**SPADINA MUSEUM
GARAGE
REHABILITATION**
285 SPADINA ROAD TORONTO, ON

MECHANICAL TENDER ADDENDUM M-01

October 3, 2023

PROJECT: Spadina Museum Garage Rehabilitation and Site Accessibility
LOCATION: 285 Spadina Road, Toronto, ON M5R 2V5
Client Project #: A22048
M4S Project #: 22626

Drawing title
**SECOND FLOOR - HVAC -
DEMOLITION AND
MODIFICATION**

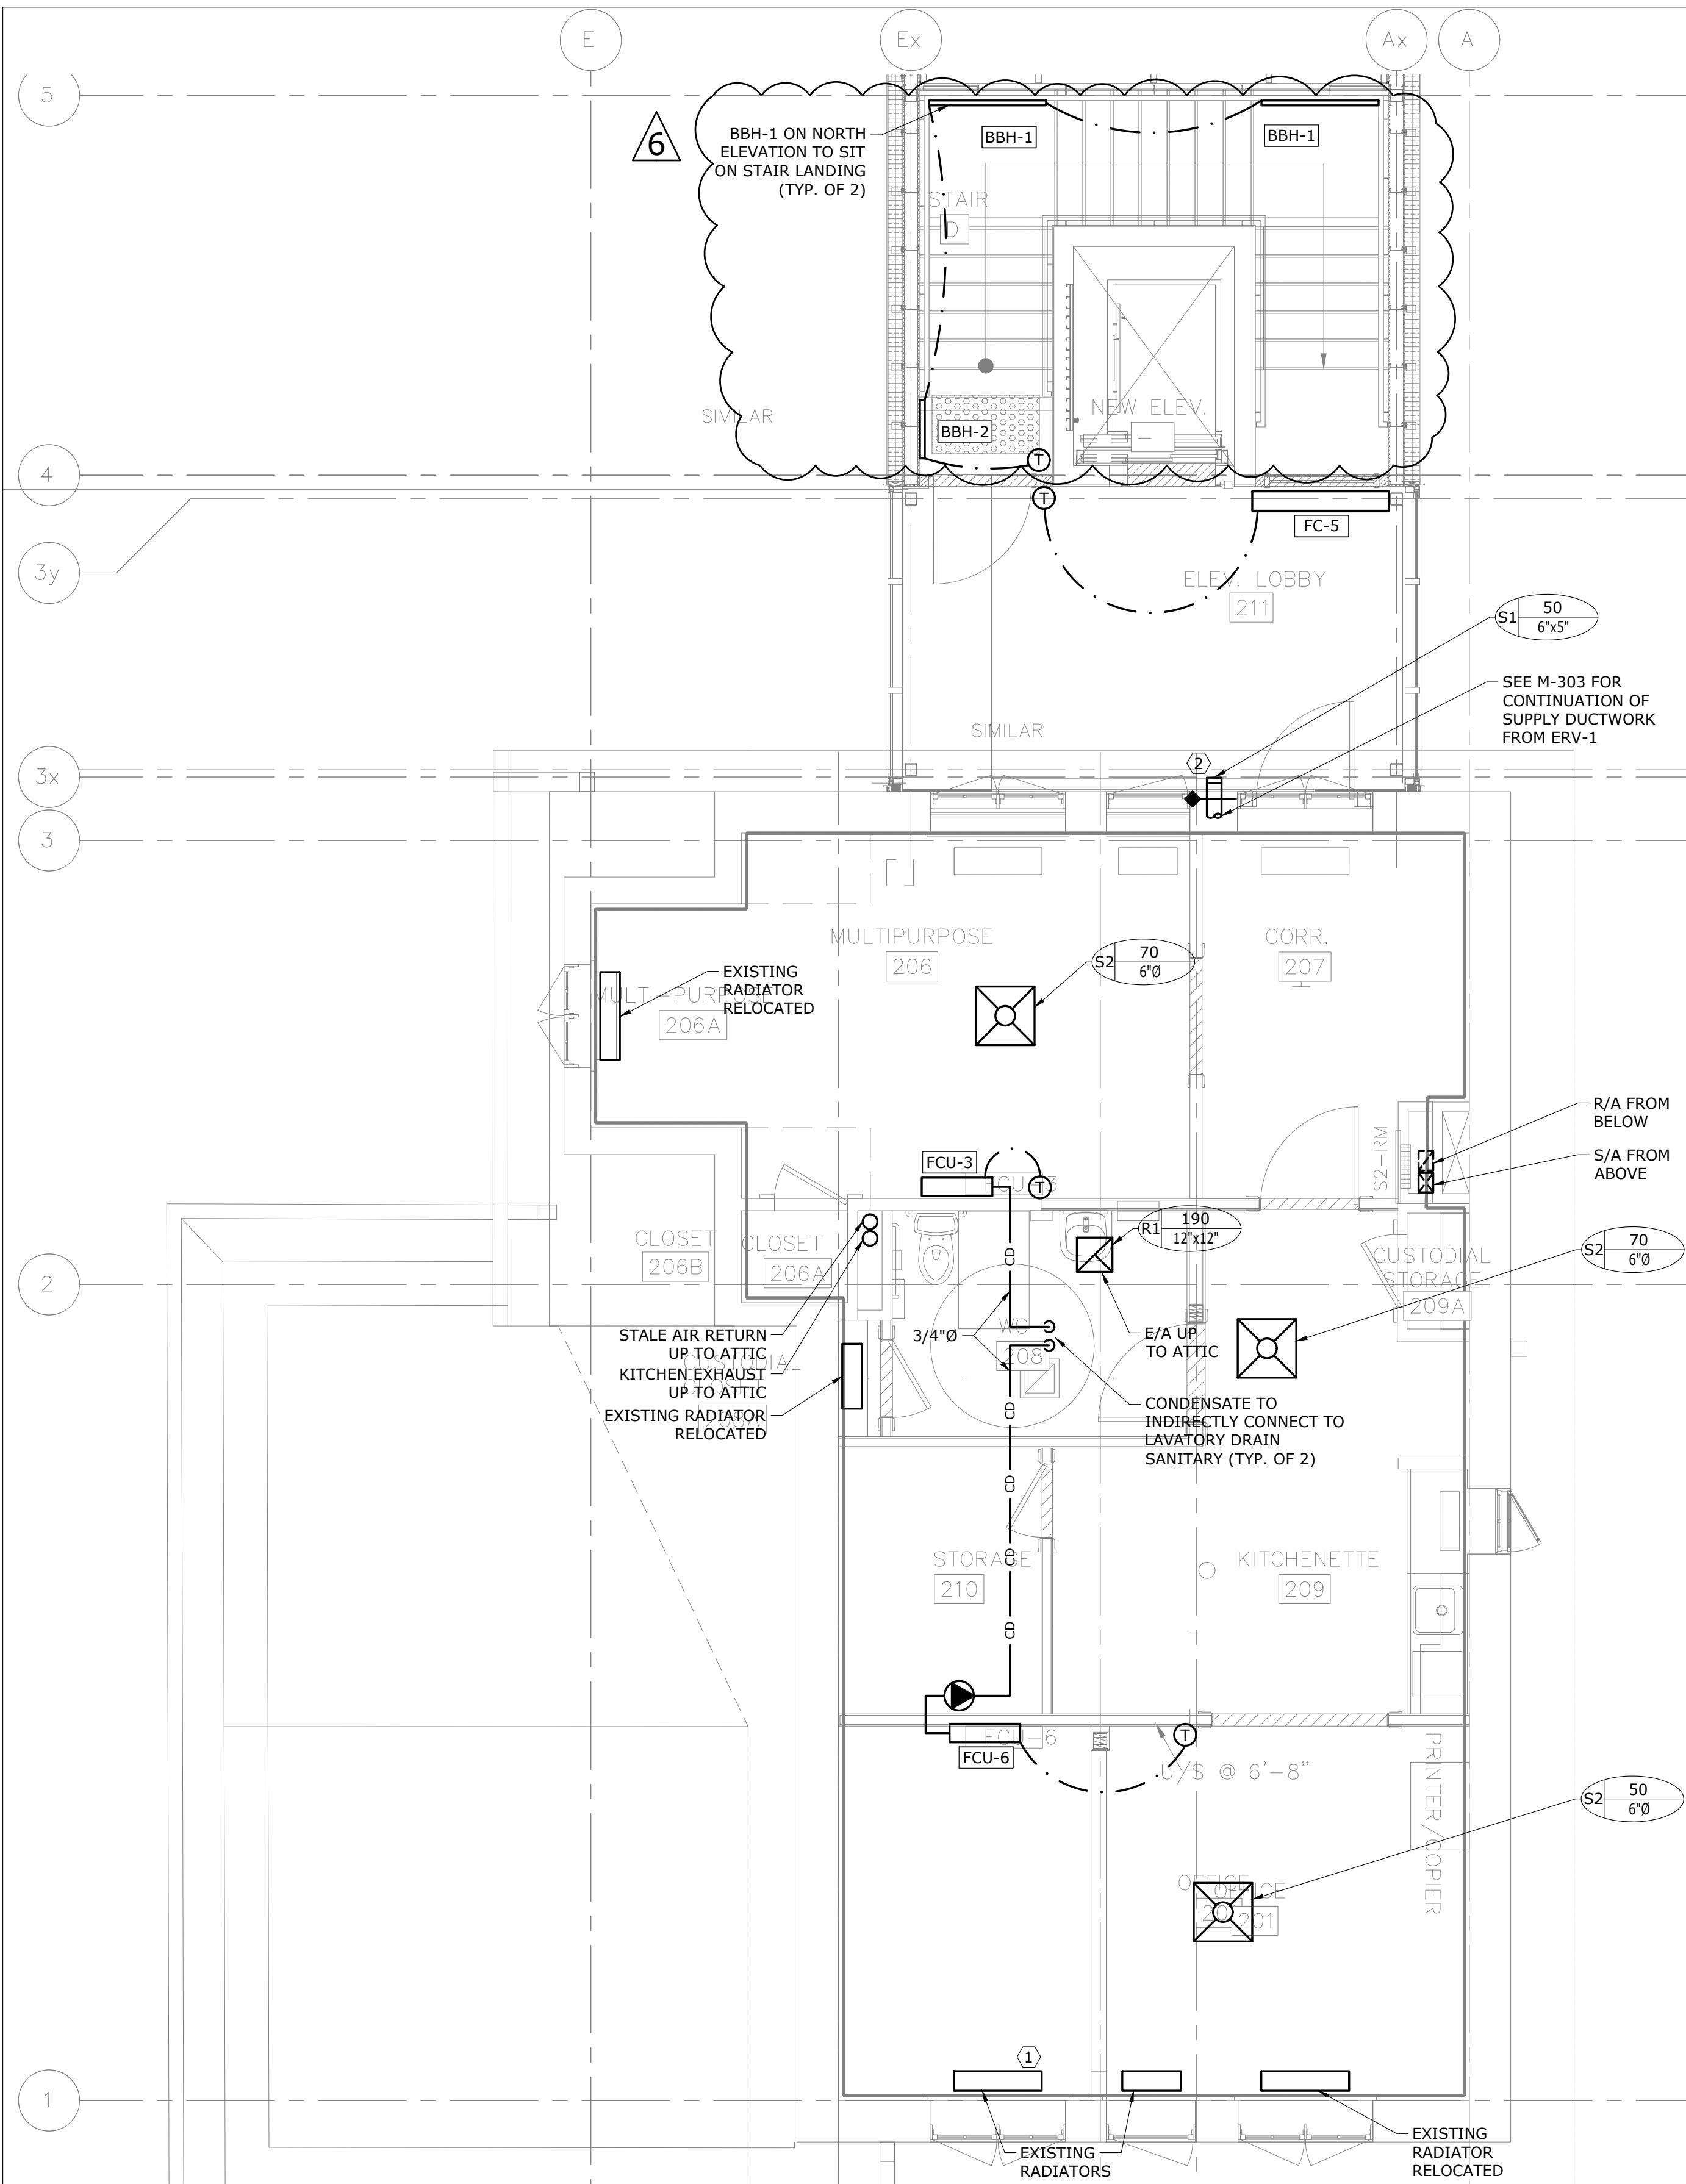
- Revision to the baseboard heater and thermostat locations.

Drawing title
**ATTIC – HVAC –
MODIFICATION & BASEMENT
MECHANICAL ROOM**

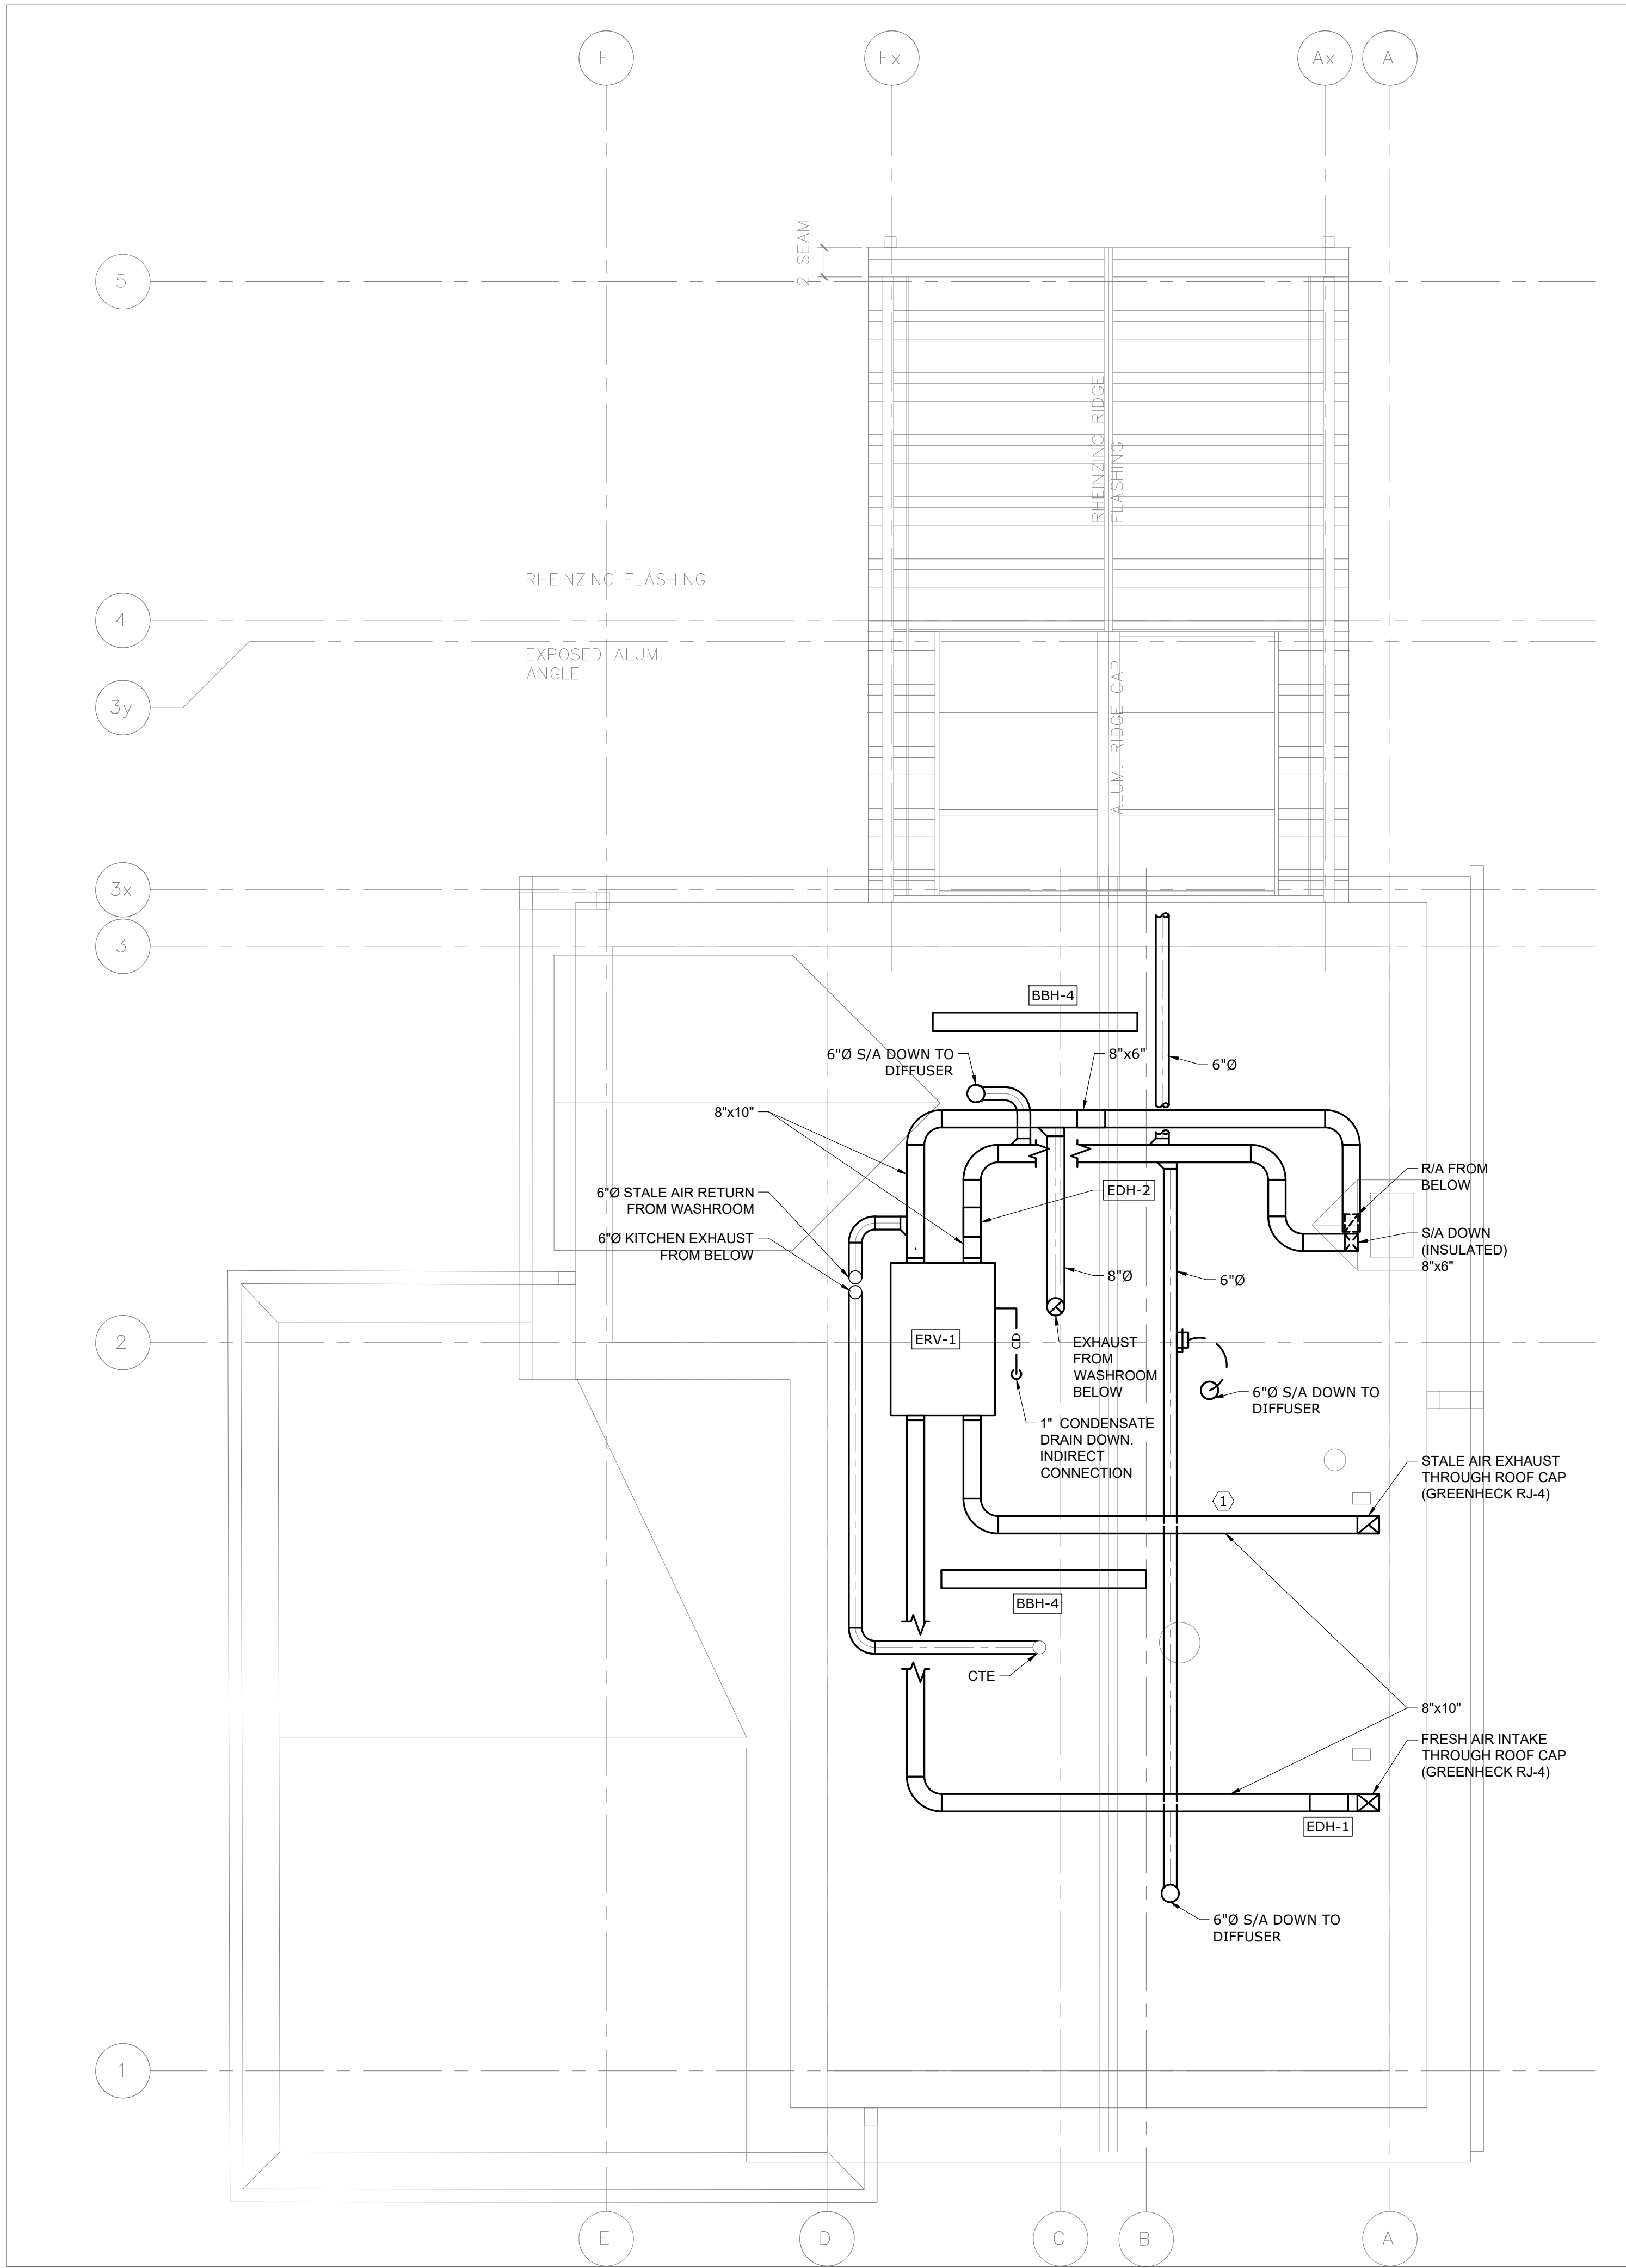
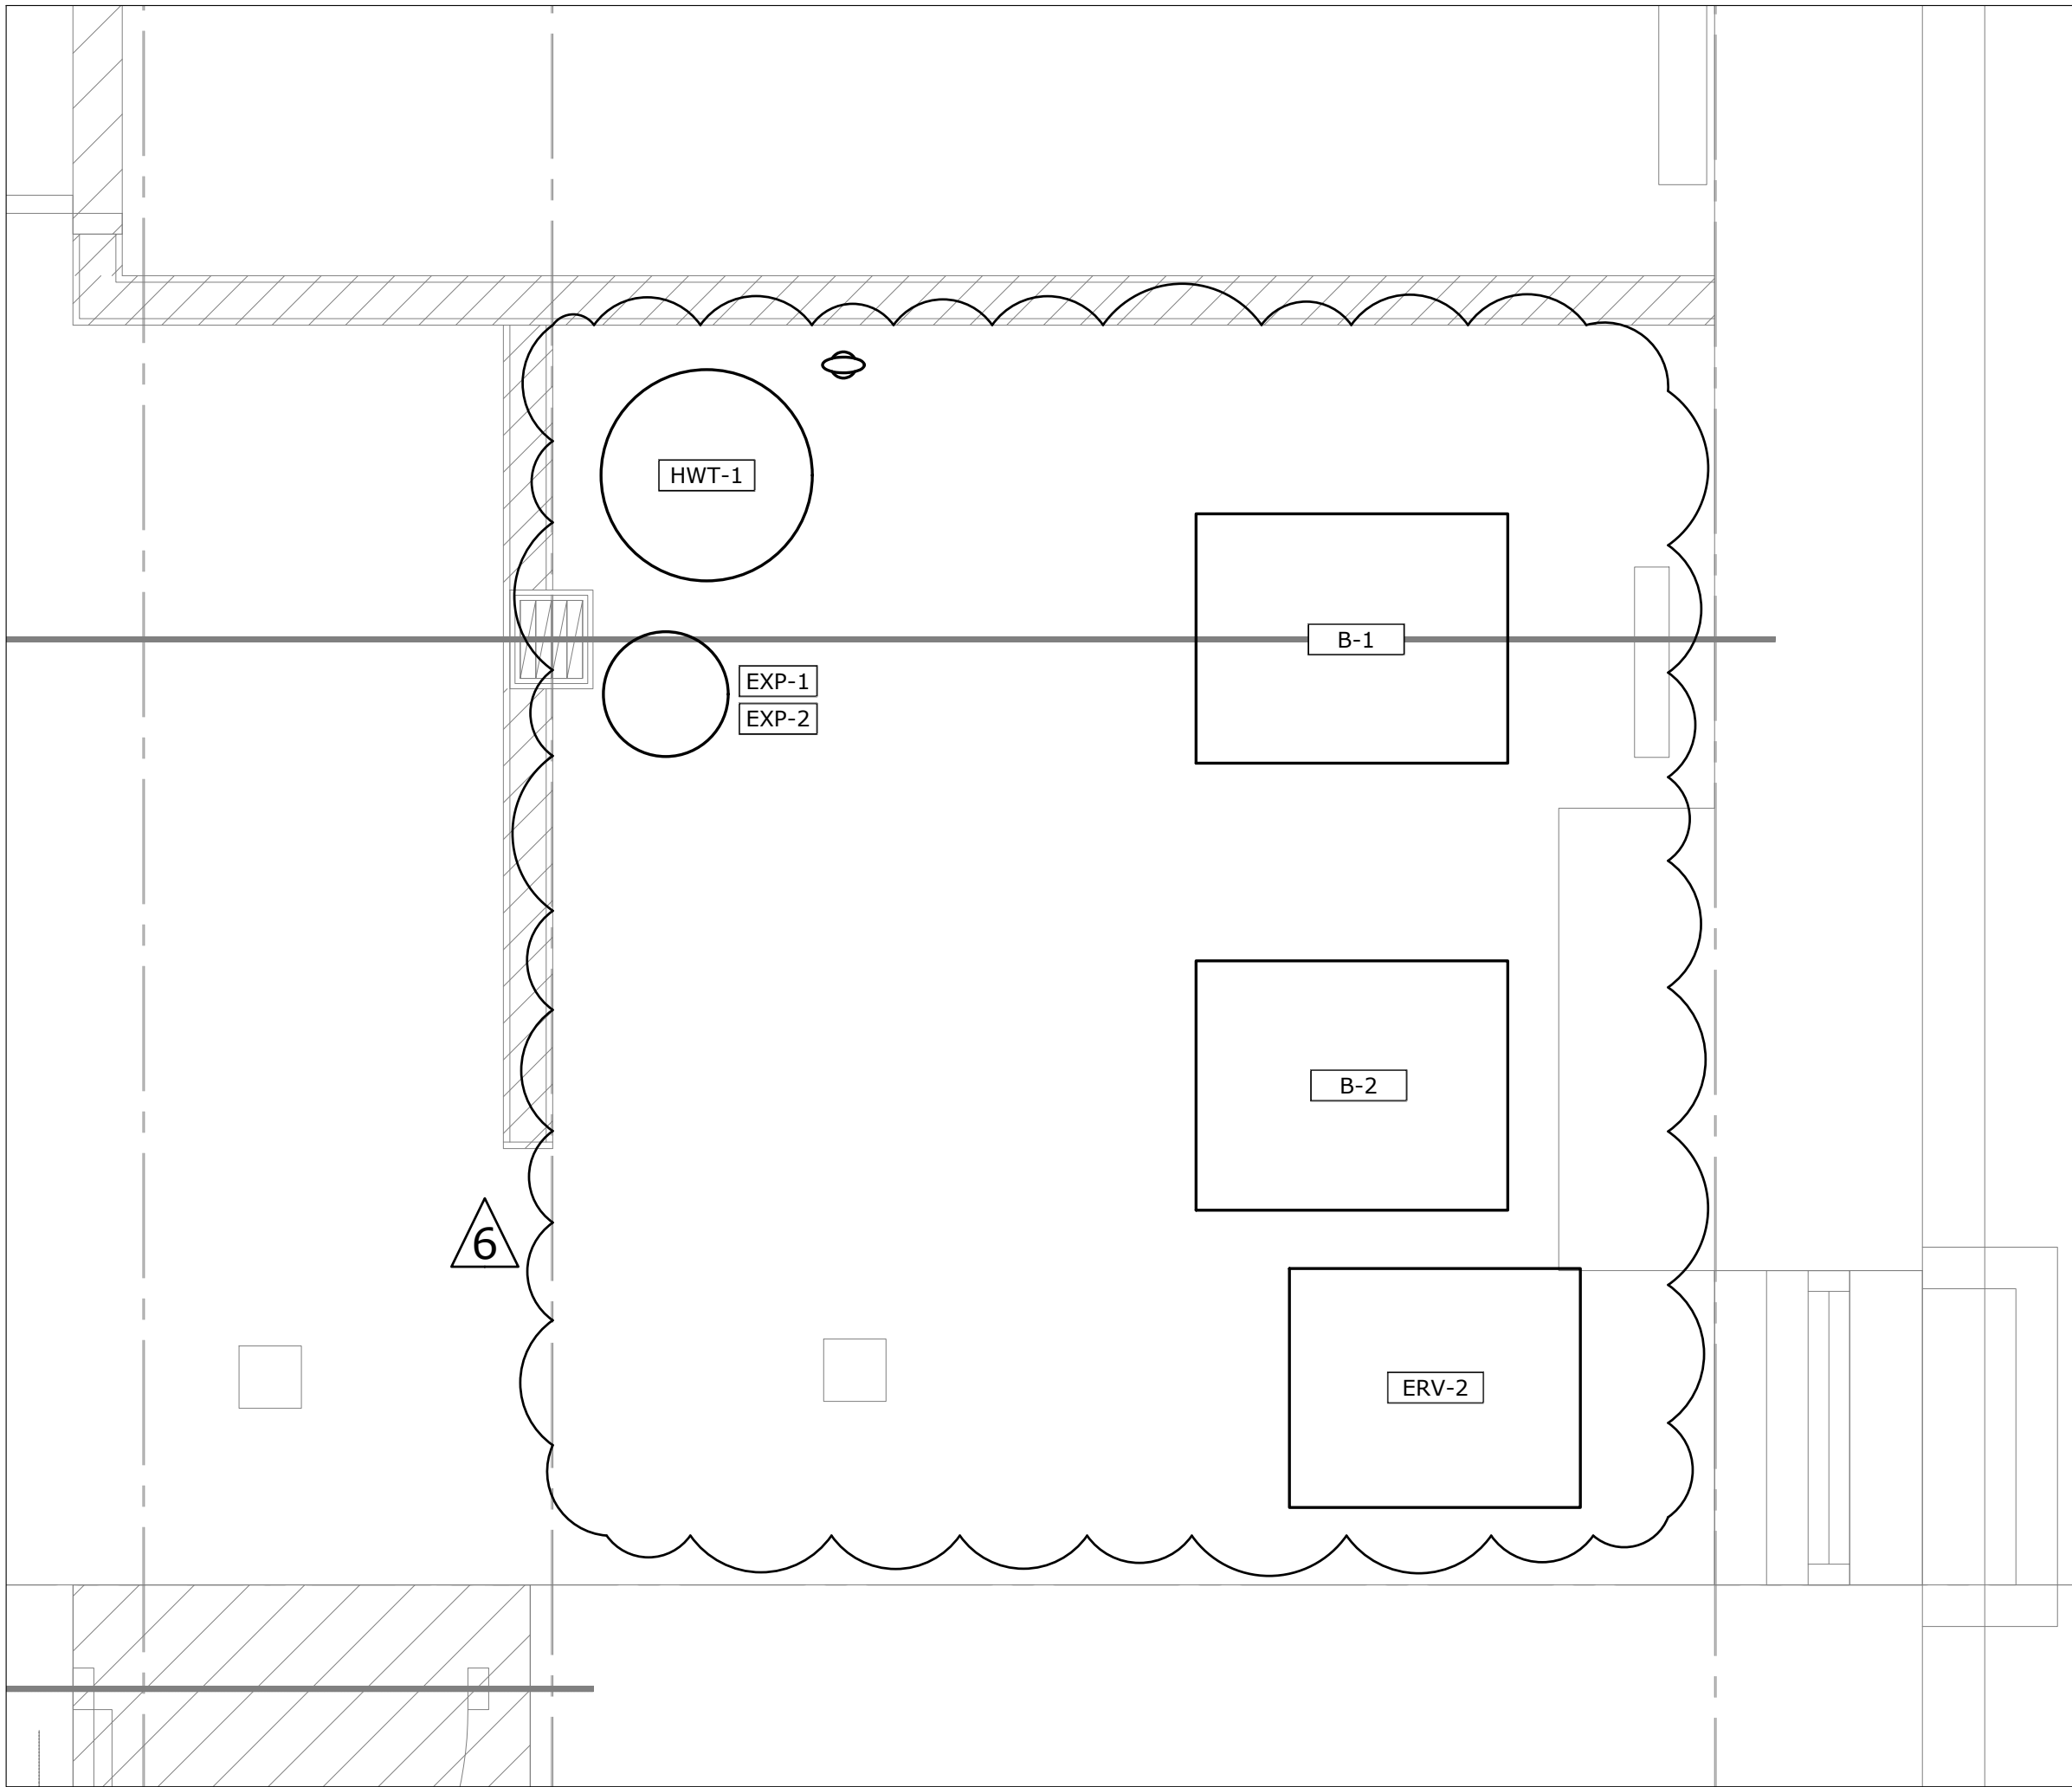
- Revision of mechanical room layout.
